Planning Ref: 26/00223/DISCON

Application to discharge C12 (CTMP) C13 (PROW) C16 (Surface water drainage) C17 (Surface water during construction) C18 (Long term management drainage) C19 (Infiltration testing) C20 (Landscaping) C23 (CEMP Ecology) C24 (LEMP) C25 (BNG) C27 (Arboricultural method statement) attached to planning permission 21/01242/FUL.

Applicant Response to LLFA Comments (April 2026)

Clump Farm

APPENDIX A – REVISED DRAINAGE LAYOUT

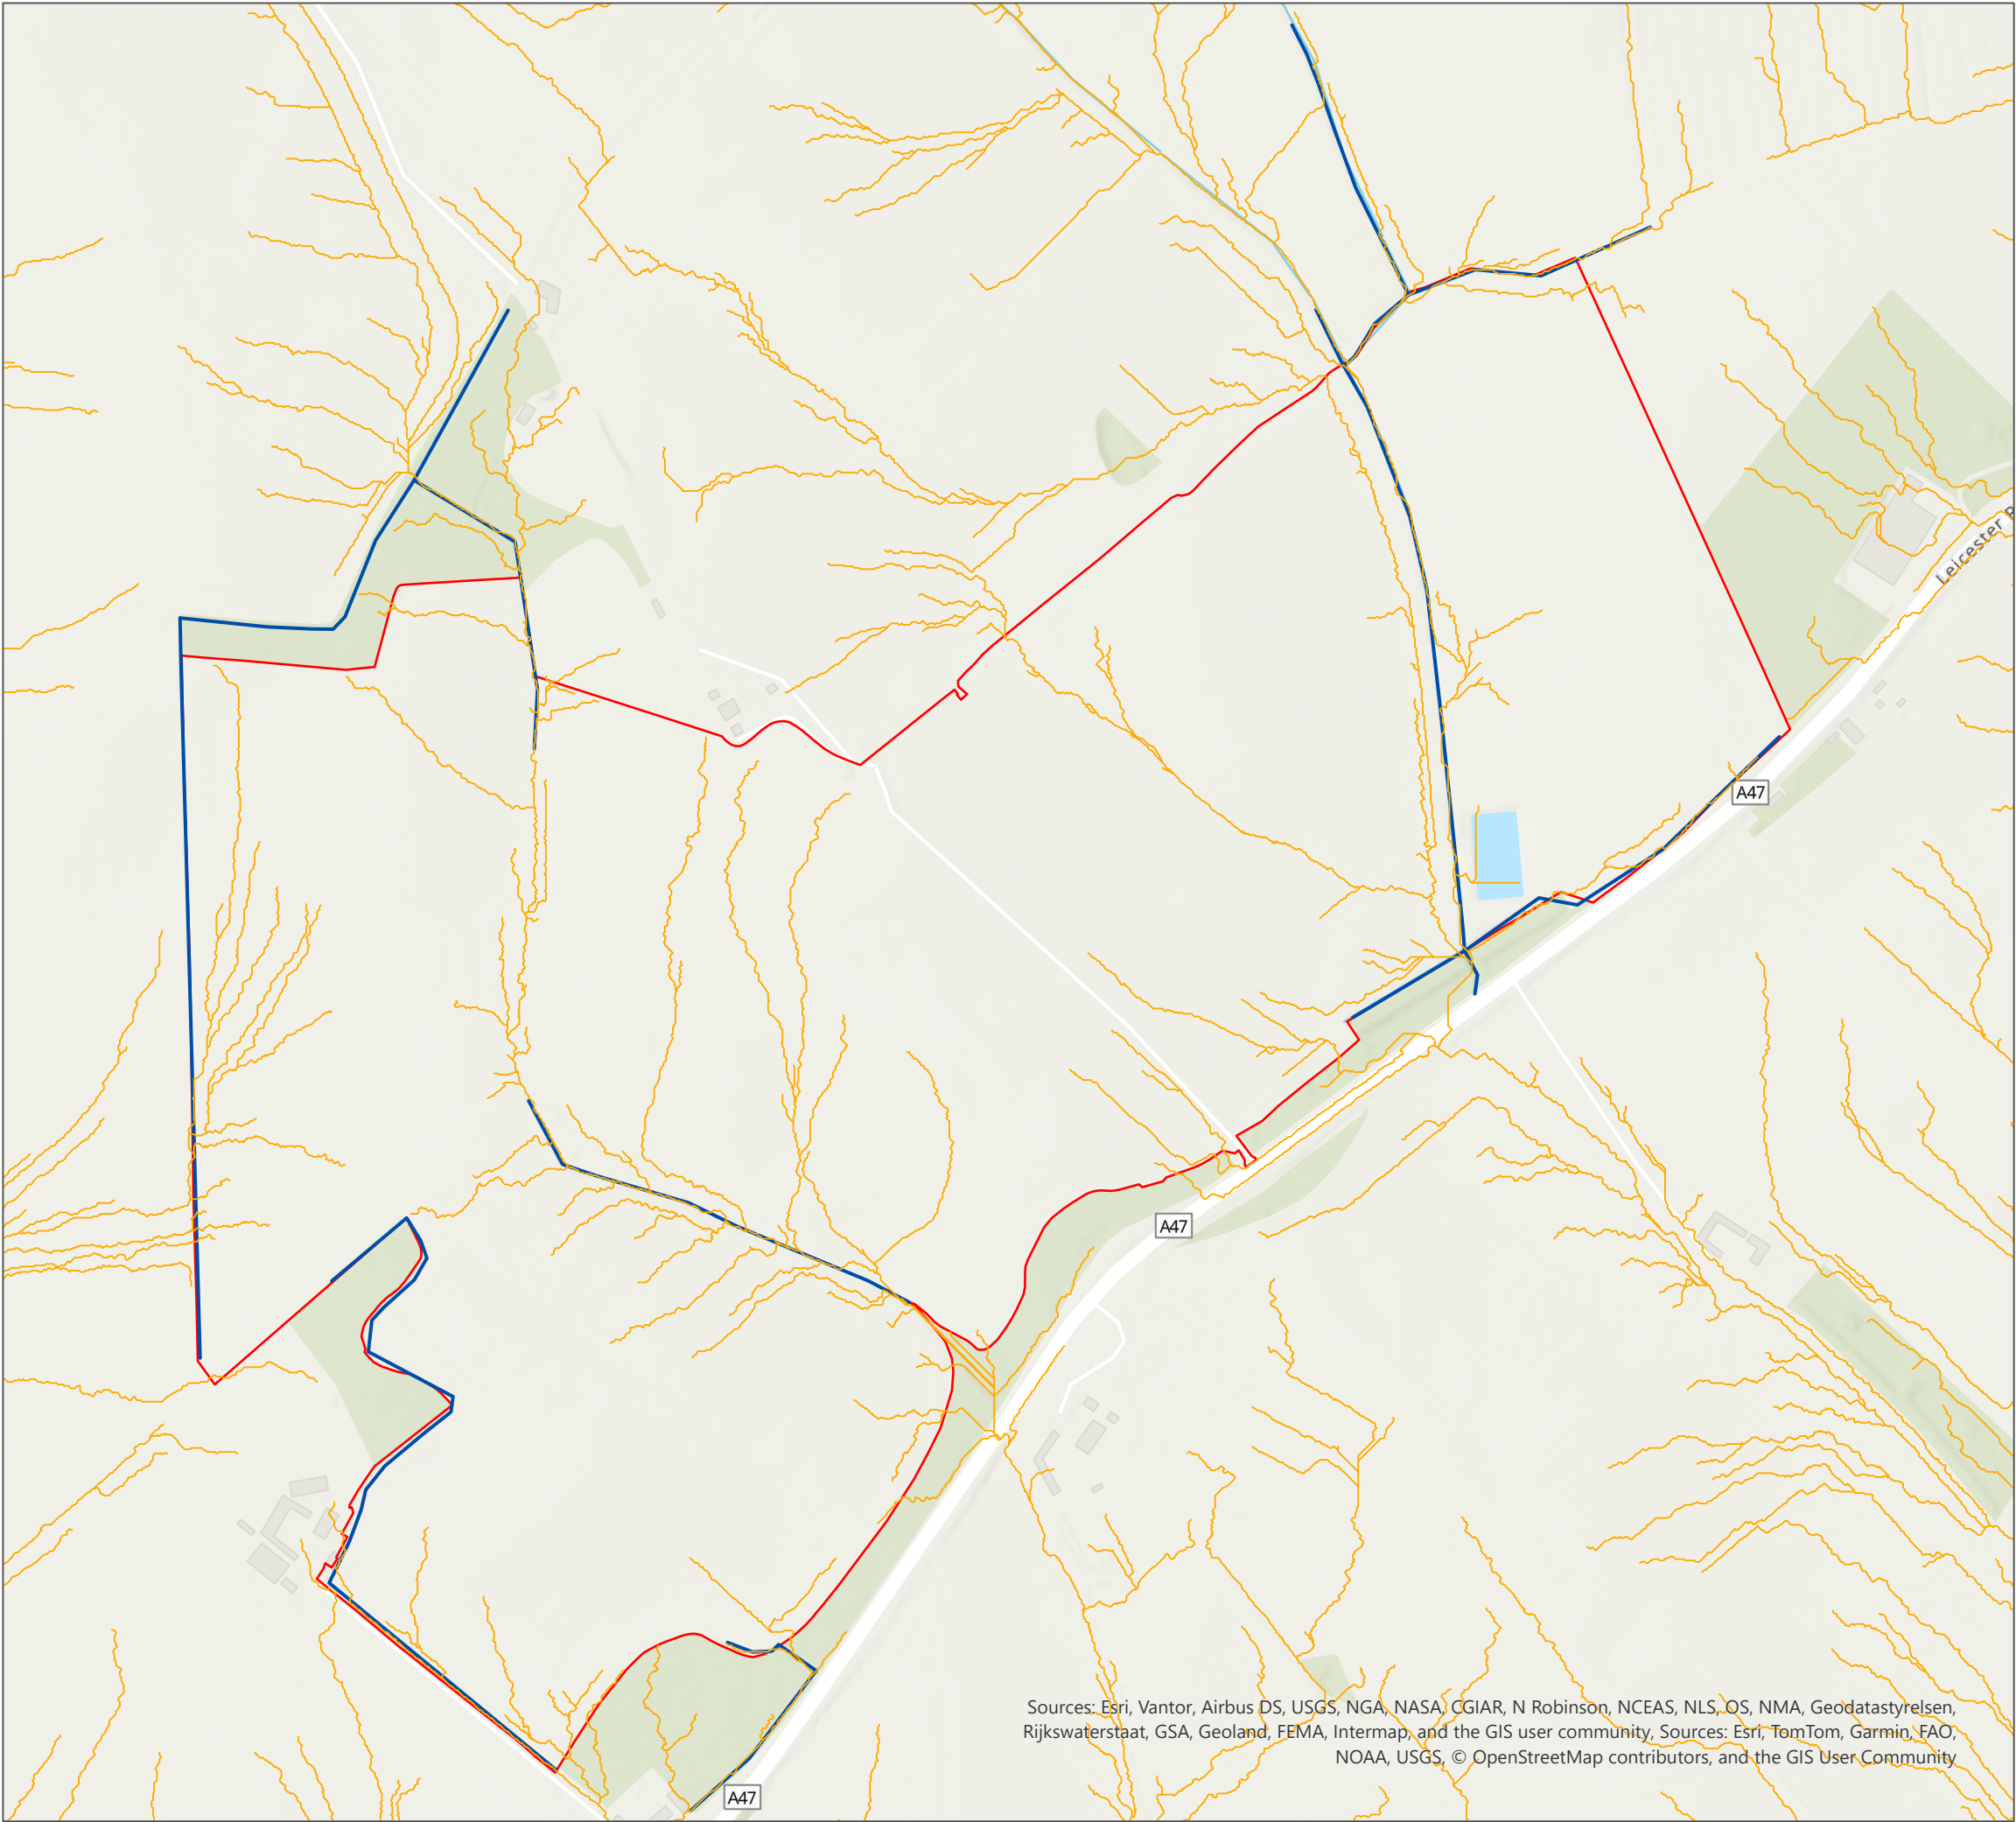
- 1. Locations of swales are shown in the site plan, however there is no details of minimum depth, width and side slope for each swale. There need adding to the submitted plan.*
- 2. Gravel strips need to be added around all transformers, substations and storage containers. These gravel strips need to be noted on plans along with details of depth and width of the gravel strip.*
- 3. The submitted drainage plan shows flow routes across the site; however, it is not clear which of these are defined ditches and which are simply surface flow routes. Any ditches need clearly marking on plans and where these are to be obstructed by construction works this should be made clear and details on how they are reconnected need to be made. Any ditch*

1. Details of the swales has been provided within the original LLFA response. The plan has been updated to include the swale details as well as the gravel strip details, see Appendix A.
2. As stated above, the drainage plan has been updated to include details of the gravel strips, see Appendix A.

The required attenuation storage for each aspect of development infrastructure and the attenuation capacity of the gravel strips is provided in Table 1. The attenuation storage required is based on the 1 in 100-year plus 40% climate change event. The capacity of the aggregate is based on a 30% porosity.

It should be noted that the substation area is 34.28 m² and not 65.92 m² as mentioned in the previous response. The total area of the substation area including the gravel strip is 65.92 m².

The dimensions of the gravel strips, including width around the development infrastructure and depth is included within the layout plan, Appendix A.
